PUBLIC INTEREST REVIEW FOR GROUNDWATER APPLICATIONS

TO: Water Rights Section Date 11/30/2015
 FROM: Groundwater Section Phillip I. Marcy / Ivan K. Gall
 SUBJECT: Application G- 18126 Reviewer's Name
 Supersedes review of _____ Date of Review(s)

A. GENERAL INFORMATION: Applicant's Name: George and Dorothy Iida County: Malheur

Figure 1: Location of proposed POA well MALH 54129, as compared to the Malheur River WAB and the Snake River to the east. Also shown is State Observation Well MALH 1678 less than 1 mile to the NW.

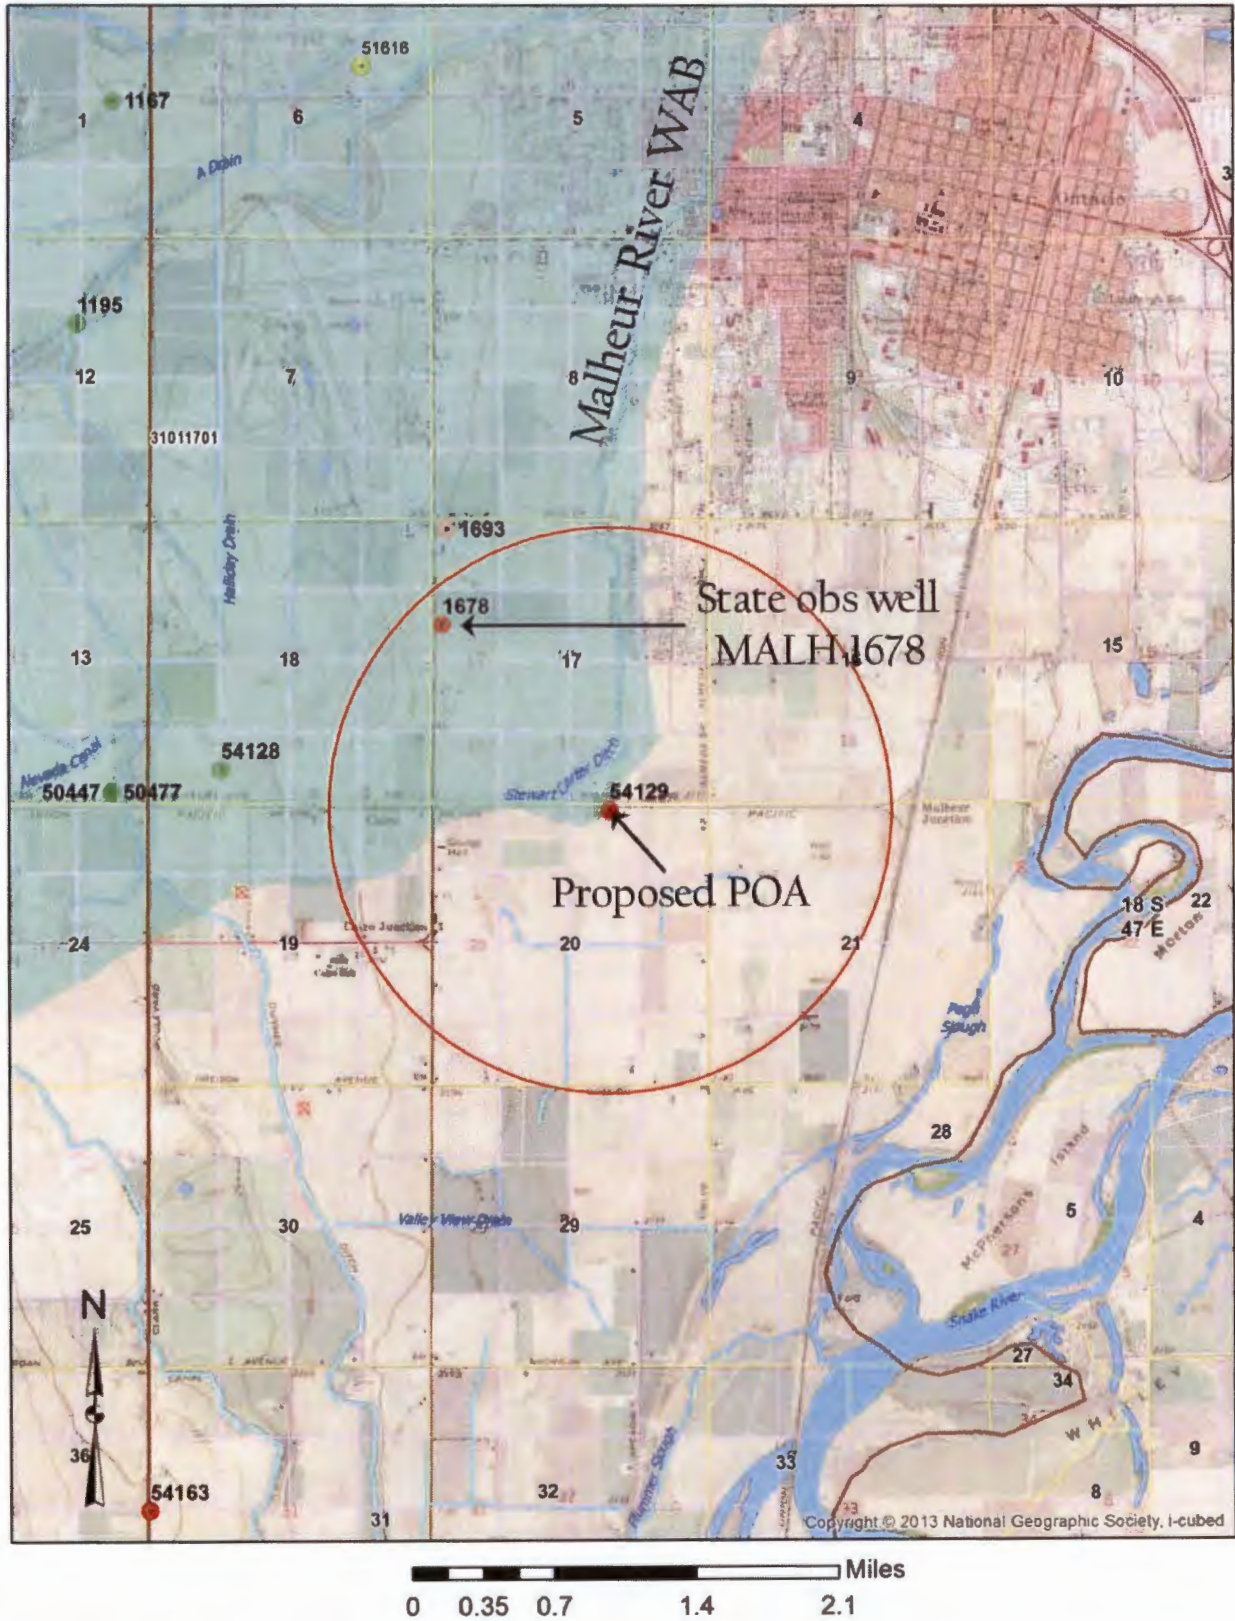
Basis for impact evaluation: Though considerably closer to the Snake River, the proposed right was evaluated here against the Malheur River water availability basin (WAB). There is no WAB associated with the Snake River and the proposed POA falls just outside the WAB for the Malheur River (31011701). Given the proximity to this WAB, I deem it appropriate to consider the potential impacts of issuing a permit to use groundwater at this location.

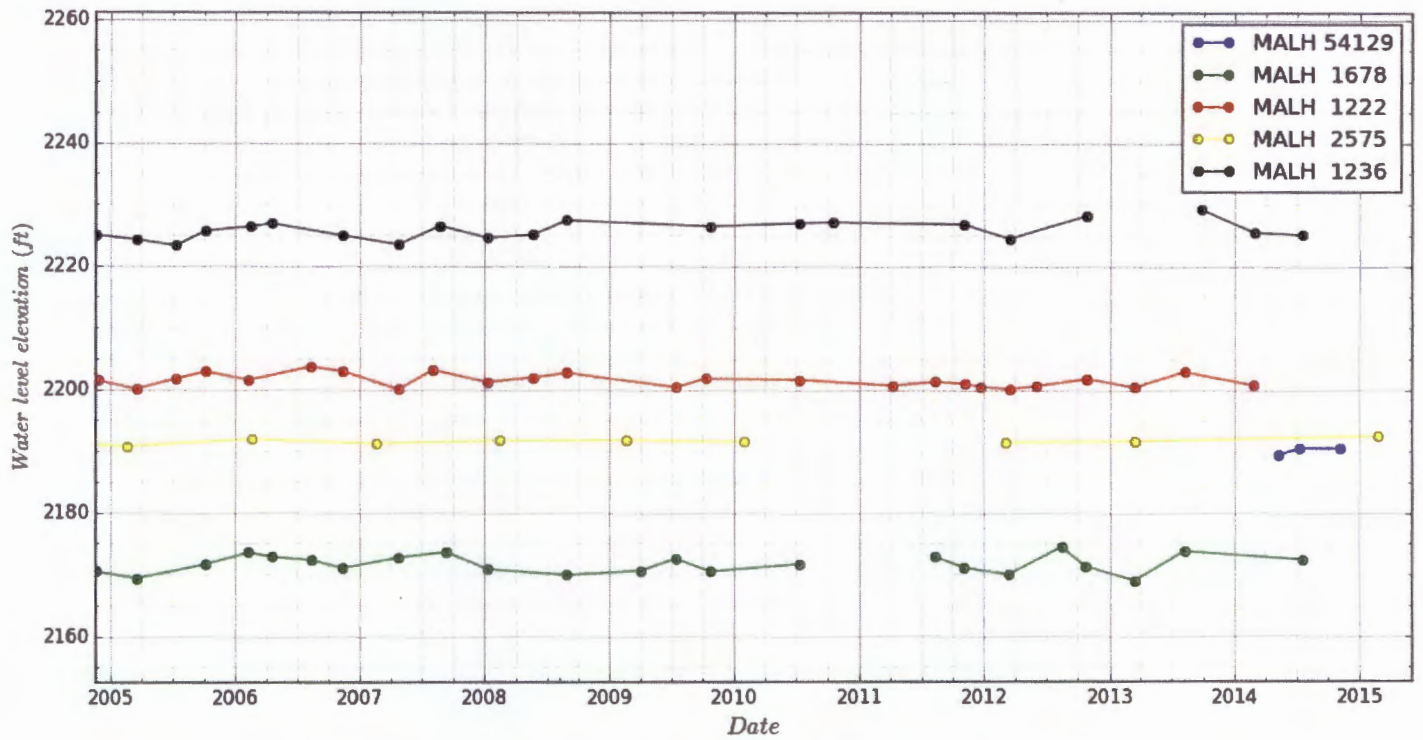
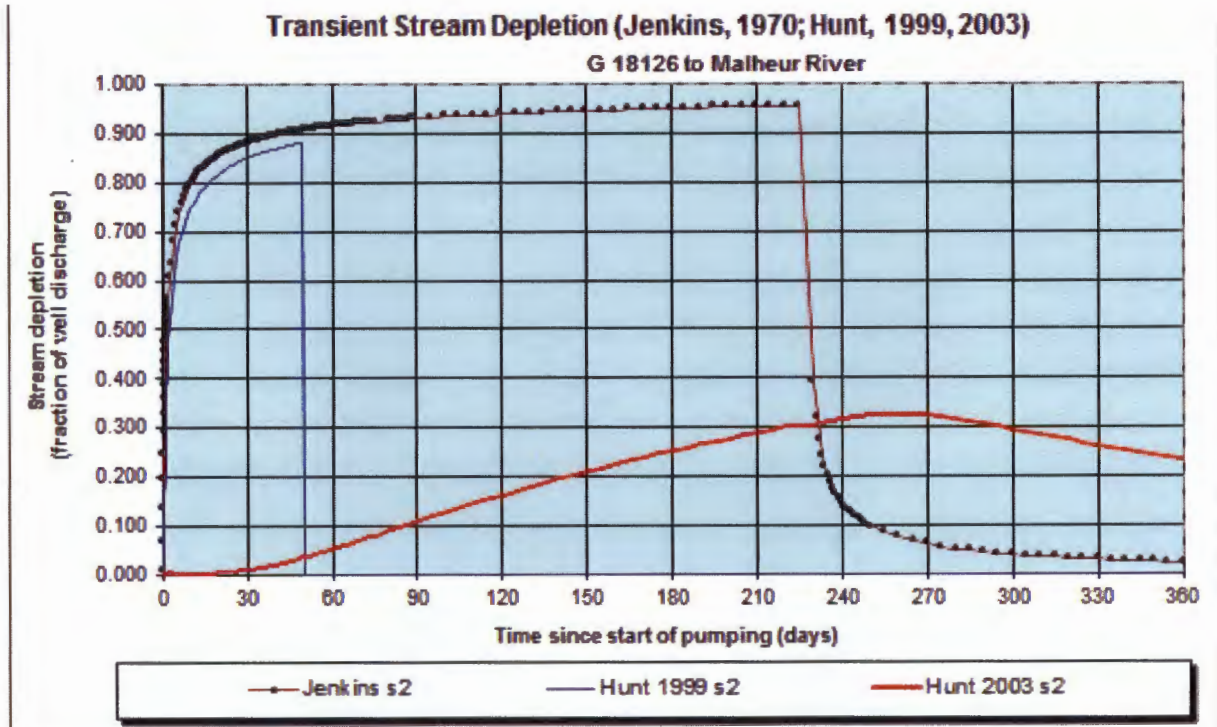
A4. **Comments:** The proposed POA well (MALH 54129) is constructed to produce from sand and gravel aquifer, likely unit Qsbf of Ferns and others (1993). No continuous confining layer exists above the production zone in this area. See attached well log.

Figure 2: Groundwater elevations are shown here from local wells during the past decade, including recent measurements of the proposed POA (MALH 54129). MALH 1678 is less than one mile NW of the proposed POA, and is constructed to produce from the same shallow sand and gravel aquifer. MALH 2575 and MALH 1236 are located 3.4 miles and 4.4 miles to the west, respectively.
